# PCN 13\_0109:

Alternate fab source for ISO TC start silicon die.  
To enable additional wafer fabrication capacity.

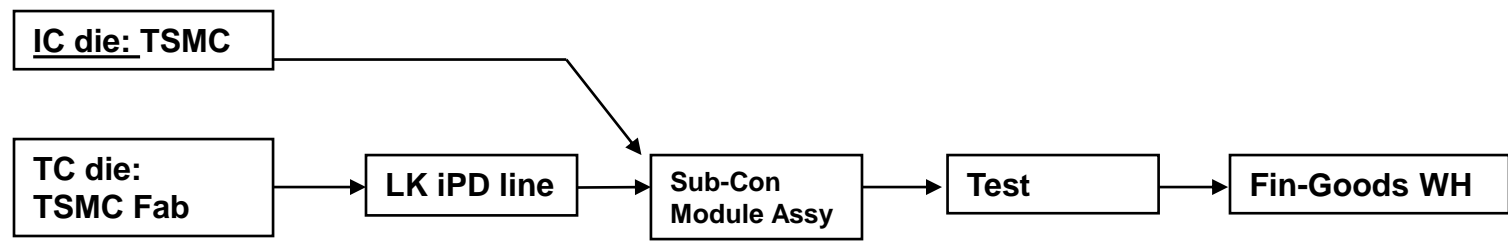
Current Flow:

Alternate Flow:
